ALEXANDRIA TOWNSHIP

MEETING PACKET FOR
February 24, 2014

STAFF REPORT

Application: Preliminary Plat for a three lot subdivision – "Rock Acres".

Preliminary Plat: ROCK ACRES

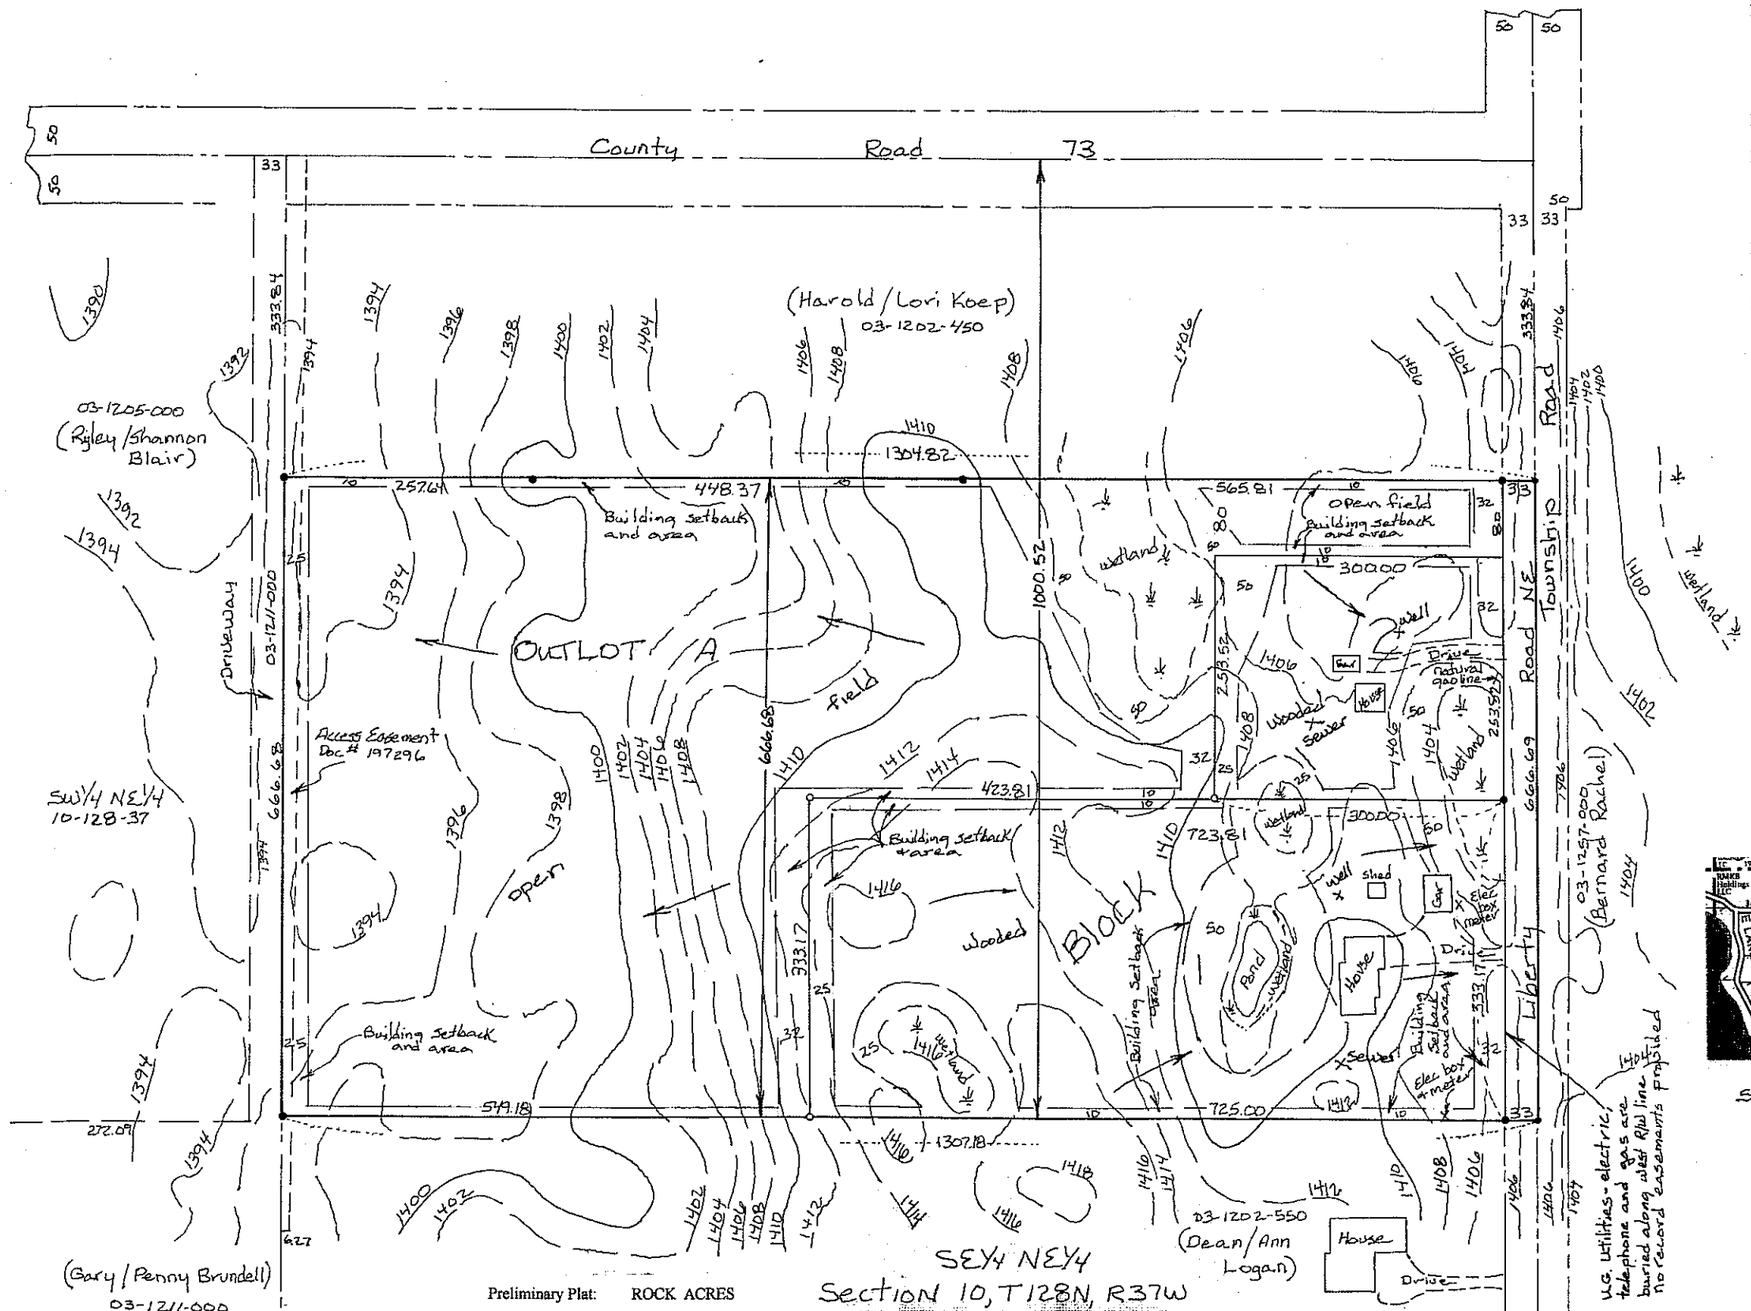
2. Given the current layout, the 80 ft wide section of Oultot A leading in from Liberty Road would be the natural location for the placement of a public road if Outlot A were ever subdivided in the future. Since the typical local township road right-of-way is only 66 ft, the proposed 80 ft width would either require that the Township take 80 ft of right-of-way at that time or the excess 14 ft of land would need to be made part of adjoining land. Alternatively, that excess 14 ft could just be joined to proposed Lot 2 right now and the strip leading back into Outlot A would only be 66 ft wide. Staff's understanding is that the 80 ft is proposed to maximize the amount of land that is available for farming right now.

3. As noted in the letter from Douglas County Public Works, the Township's Access Spacing Guidelines (see Appendix A of the Subdivision ordinance, copied into this report earlier) recommend at least 1/8 mile (660 ft) spacing between driveways and between driveways or low-volume public roads and other public roads. The two existing driveways serving the existing homes are about 330 ft. The next closest driveway to the south is about another 330 ft. A new driveway leading into Outlot A would be about 120-170 ft from the nearest driveway now and about 350-400 ft from the County Road 73 intersection.

(a.) If there is to be an additional driveway into this land (to serve Outlot A or any additional lots beyond what exists now), there is no way to meet the Township's access spacing guidelines. In the past, the guidelines have been relaxed when reasonable requests for access require it. In many cases, those requests are for existing parcels of land not being subdivided. In cases where a new subdivision is taking place, a higher level of scrutiny is probably justified, although flexibility will still be required at times. The purpose of the spacing guidelines is to prevent traffic congestion and avoid traffic safety concerns; typically the more places that people are entering/exiting higher-speed roadways the more opportunities there are for accidents with vehicles traveling at those higher speeds.

As proposed on the preliminary plat drawing access to Outlot A is through an 80 feet wide strip off of Liberty Road. All that is allowable for wetland filling would be to cross the wetland as shown on the enclosed aerial photo. Construct of a Township type road would not be allowable.

Another comment is that the remaining 80' of frontage for access to Outlot A from Liberty Road would not meet Douglas County's access spacing guidelines.

1. The applicant shall dedicate enough land so that there is a full 50 ft of right-of-way along Liberty Road for all three proposed lots.

PIN: 03-1202-480

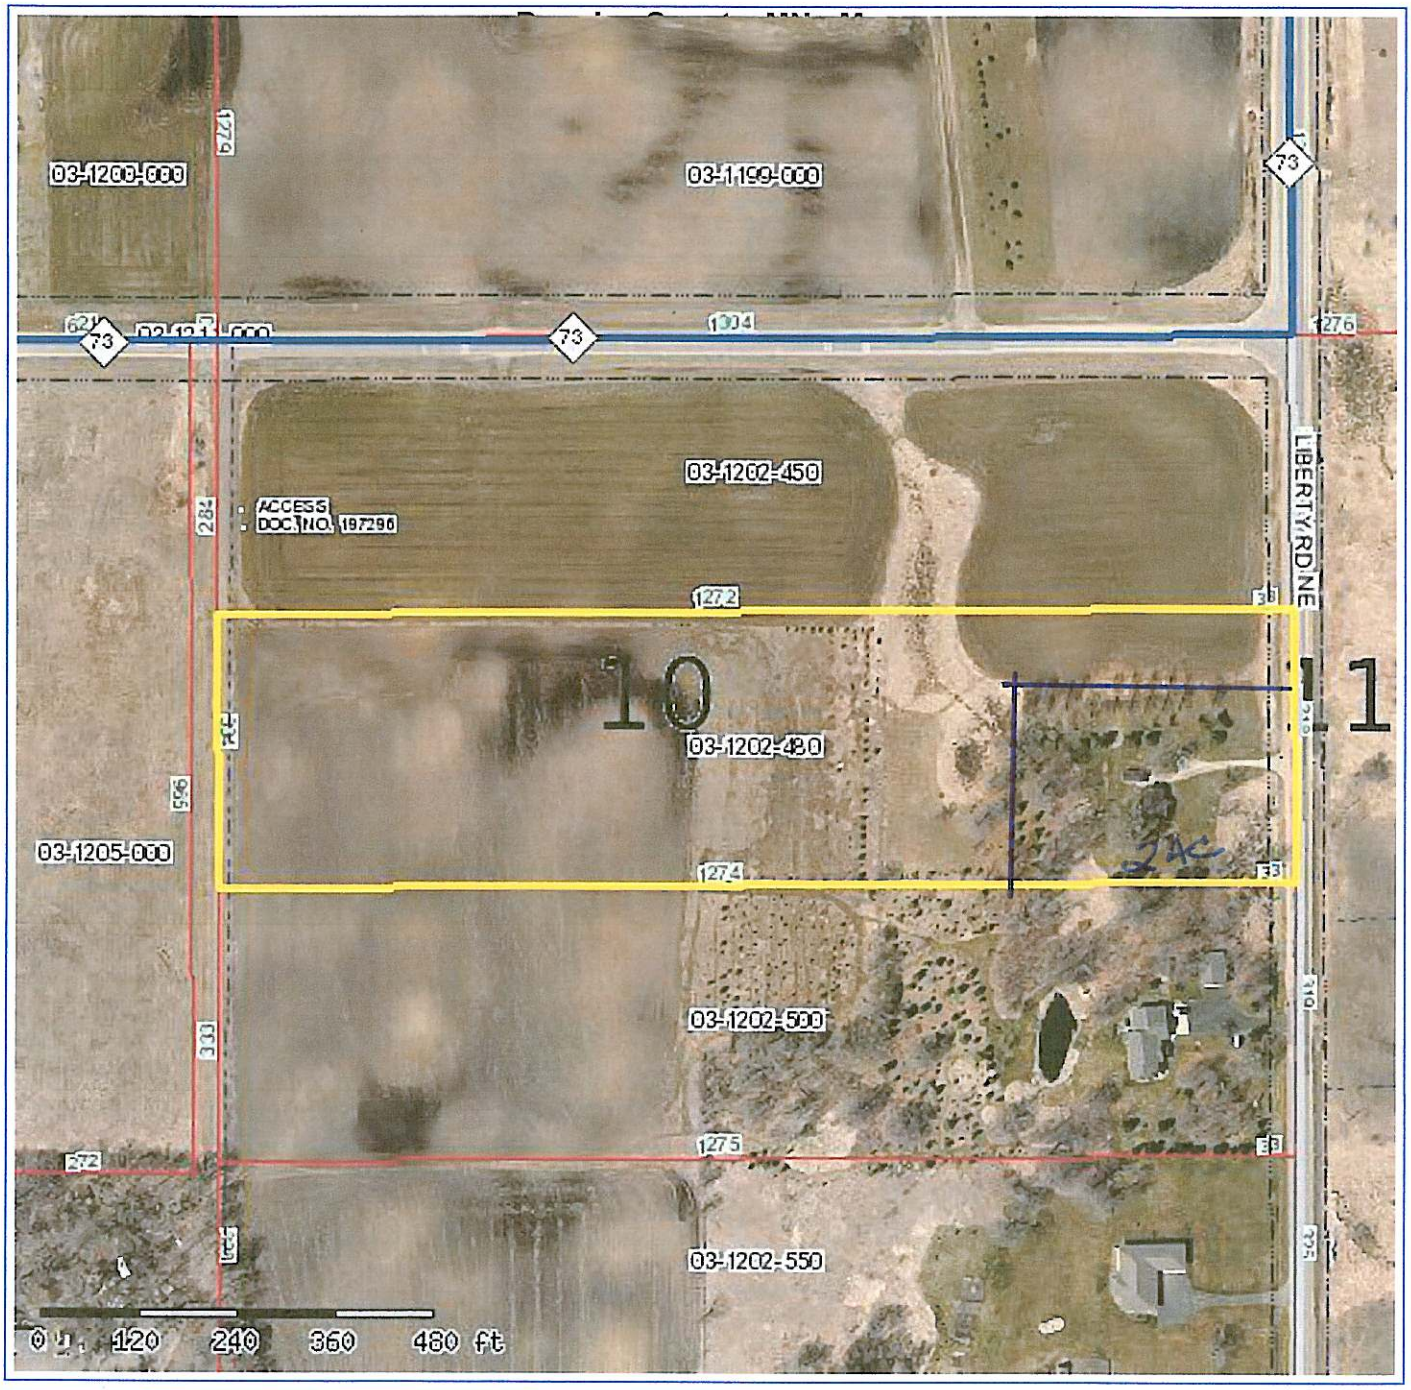
I have reviewed this planed Subdivision of 2 acres located in Section 10 Property ID # 03-1202-480 of Alexandria Township, T.128.N – R.37.W. The soils indicated in the Soils Survey Book which is NeB, WaB. The soils warrant different types of septic system designs. There should be enough room on This lot for two (2) septic sites as one is existing at this time. Just northwest of the existing one.
